COMMUNICATION: PLANNING COMMISSION

MEMORANDUM TO: Planning Commission

DATE: May 14, 2008

SUBJECT: Staff Analysis Z-307- This application requests rezoning of a 6.58-acre parcel, known as the Summit Shopping Center (Parcel N182), located in the northeast quadrant of Goshen Road and Girard Street at 559 Girard Street, in Gaithersburg, Maryland, from the existing C-2 (General Commercial) Zone to the MXD (Mixed Use Development) Zone, in accordance with § 24-196 of the City Code (Map Amendments). The property is adjacent to Hidden Creek Land Bay III. The sketch plan proposes seven 3- to 5-story residential structures containing 300 multiple-family dwelling units, up to 20,000 square feet of commercial/retail space and structured parking¹.

Portion of the Illustrative Site Plan, Exhibit #130

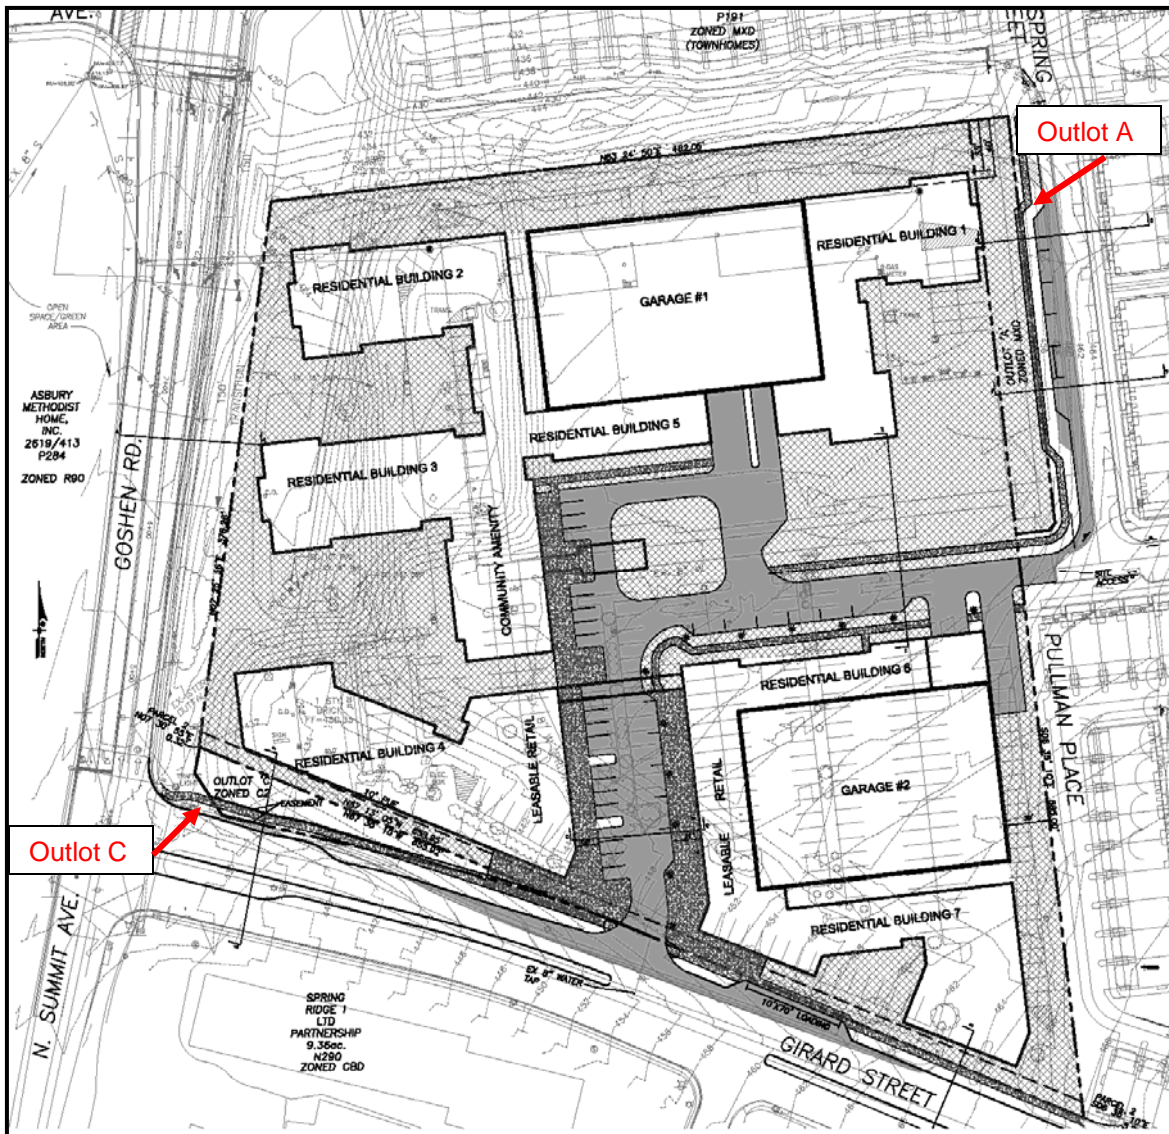
The structures will be between three and five stories, and there will be a maximum of 300 residential multiple family units with above ground structured parking. The applicants are proposing to have the apartment buildings closest to Hidden Creek Land Bay III at a three-story level. In addition to indoor amenities, the illustrative plan incorporates a swimming pool courtyard and another open courtyard facing Goshen Road. The property is connected, as required by City Code, to Hidden Creek Land Bay III via Raven Avenue.

Building setbacks are also established by both the sketch plan (Exhibits #140 through #143) and the illustrative plans (Exhibit # 130). The minimum setback from Girard Street right of way and Outlet C is ten feet and the setback from the Goshen Road right of way is 15 feet. The minimum northern setback is 35 feet, although a major portion of that structure is 40 feet to allow for adequate afforestation area. There is a one-foot setback between the eastern side of the building and the property line adjacent to Outlet A. The building at the southeastern corner of the project is setback 30 feet from the property line.

4. The Applicants shall maintain the setbacks established on both the Illustrative and Sketch Plan (Exhibits #130, #140 and #141) ;
5. The Applicants shall provide parking in a combination of above and below grade structures, plus surface parking. A minimum of 90 percent of parking exclusively for retail and residential use must be in structures. Parking calculations (specifically the one bedroom units at 1.75 spaces per unit) and aisle width are to be in accordance with the adopted Parking Ordinance of the City of Gaithersburg;

Cross section showing the three story wing adjacent to Cedar Spring Street¹⁶

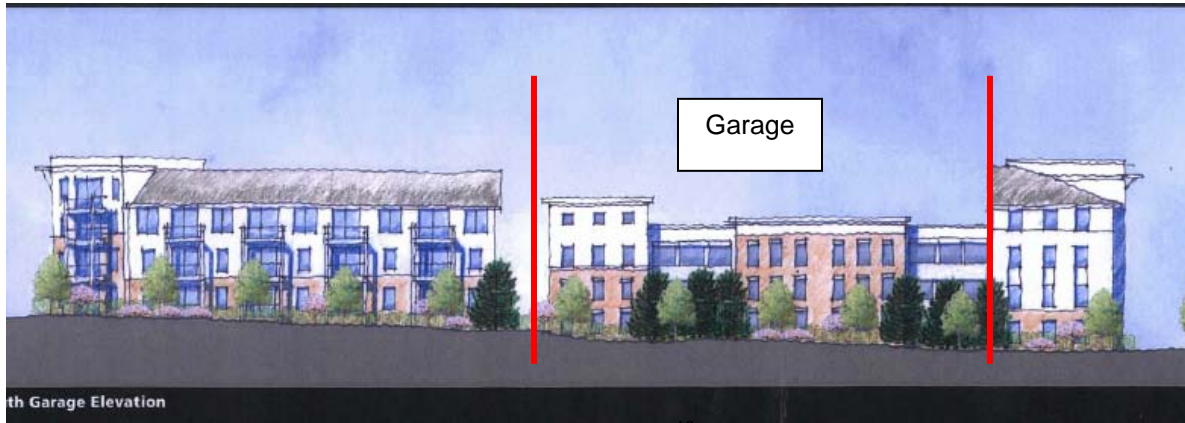
Revised perspectives of the building facing Cedar Spring Street were not submitted; however, according to the applicants' letter, this wing, identified as Building One on the sketch plan, which borders the northern edge of the large green will be reduced to three stories for a portion of the wing.

Note that a portion of the wing to the right of the above illustration will only be three stories as it faces Cedar Spring Street in accordance with the statement in Exhibit #126.

2. Future development of the site shall include up to 300 residential units in structures three to five stories in height;
3. At the submission of Schematic Development Plan Application, the Applicants shall provide plans with heights of buildings in accordance with the letter from Barbara Sears and Yum Yu Cheng, Linowes and Blocher, dated April 29, 2008 (Exhibit #126);
